LAKE WASHINGTON SCHOOL DISTRICT
KIRKLAND MS ADDITION

KIRKLAND MIDDLE SCHOOL MASTER PLAN AMENDMENT

Permit #: ZON22-00800
Project Name: Kirkland Middle School
Project Address: 430 18th Ave
Date: Jan 21, 2022

RE: Kirkland Middle School Addition ZON22-00800
Zoning Submittal Comments & LWSD Response Summary

EXTERIOR
ELEVATIONS

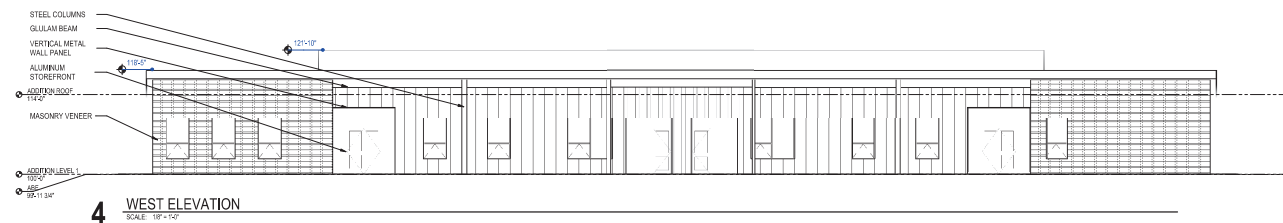
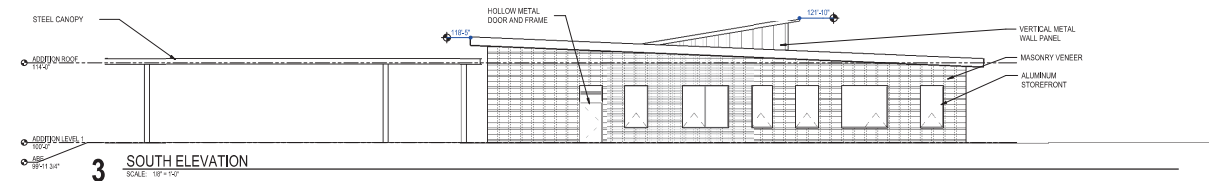
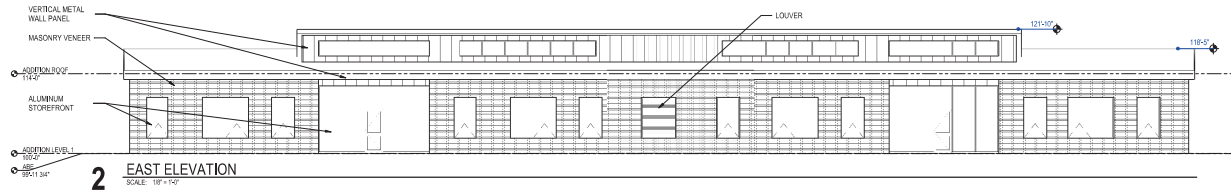
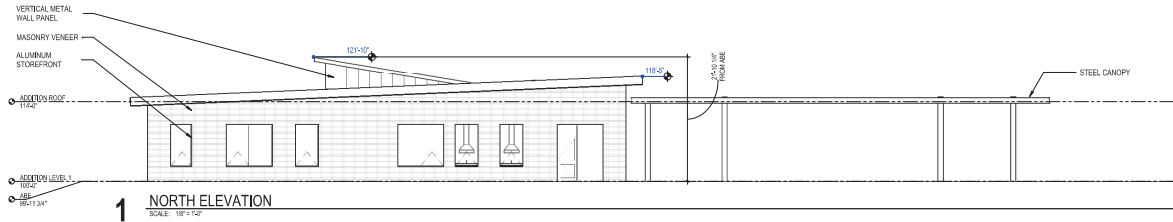
4. Based off <http://permits.kirklandwa.gov/WebDocs/2020121310/32443a0b-19cd-40e3-b7f8-bad1d95e4e3c.pdf> (Page 2), the new building height is proposed to be 22 feet. Is my understanding right? What is the proposed height of the ceiling? Is it going to be 14 feet or 22 feet?

5. **Public Comment: Doors and Windows**

"Based off <http://permits.kirklandwa.gov/WebDocs/2020121310/32443a0b-19cd-40e3-b7f8-bad1d95e4e3c.pdf> (Page 16), I do see door and windows on south side of building facing 18th Ave. The fencing is chainlink that is see through. Based on Page 14, I do not see any new trees added on the south side of the building that will give additional privacy."

LWSD Response: *Final plans will be developed as part of the building permit process. There will likely be two classrooms that will have South facing windows to allow daylight into the classrooms. There may be access doors for back-of-house/support spaces to the South, but main entry doors will be on the West. The type of fencing is still under consideration. New trees and landscaping will be added as part of the addition.*

LWSD Response: *Final design will be developed as part of the building permit. The highest point of the building is expected to be at about 20'. Attached for reference is an updated floor plan and building section plan.*

Kirkland Middle School Addition
ZON22-00800
Floor Plan - March 14, 2023

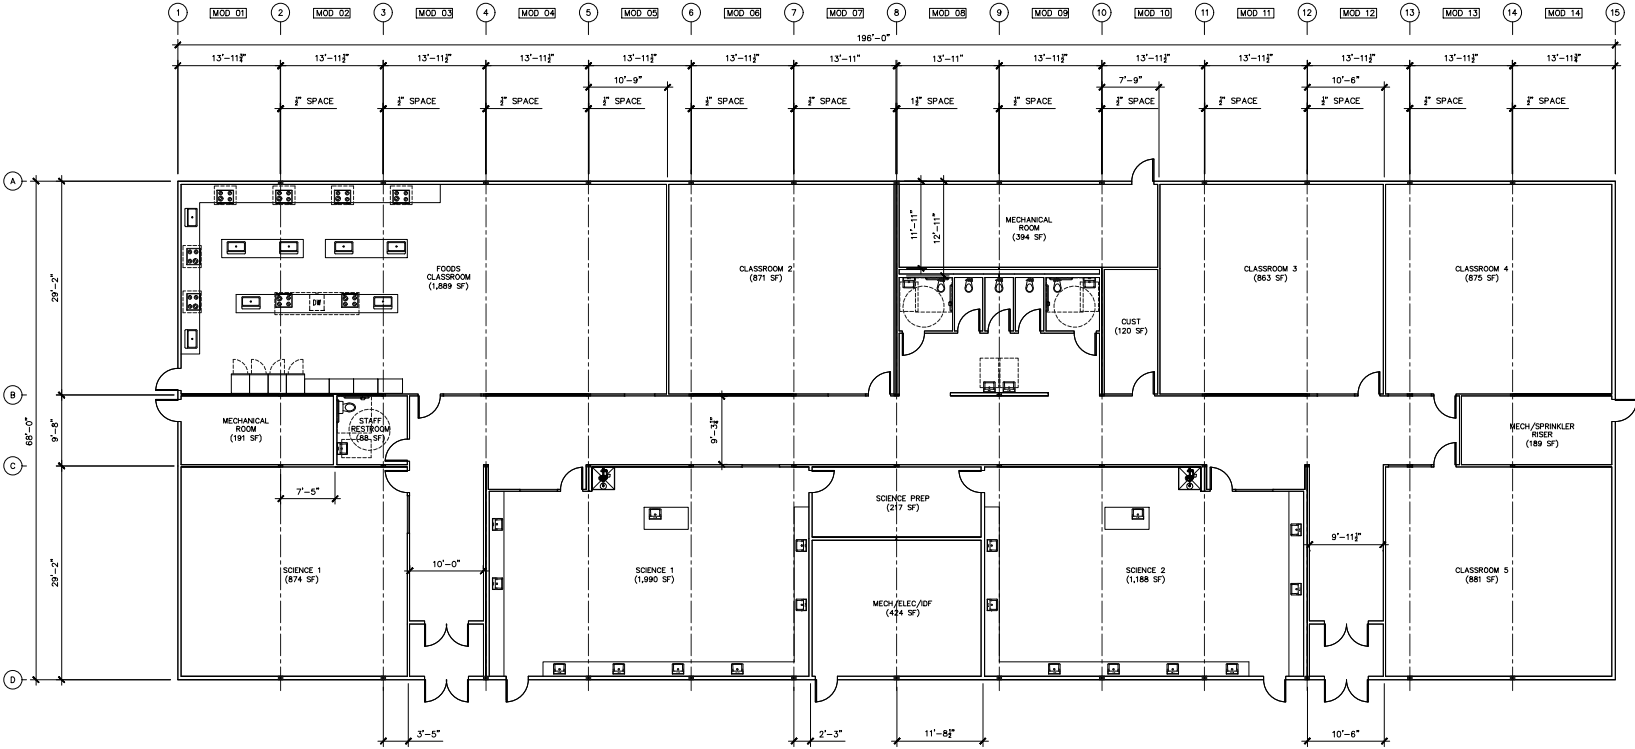
3. **Public Comment: Location of the building**

Several comments and questions were received regarding the location of the new addition.

6. **Public Comment: Building Height**

LWSD Response: *Several factors were considered in determining the optimal location and size of the building and they're listed below. The need to accommodate the existing easements influenced how far East the building needed to be moved.*

Note: the final building footprint and final plans will be developed as part of the building permit. The building dimensions will be approximately 68' wide x 196' long. Attached for reference is an updated floor plan and building section plan.
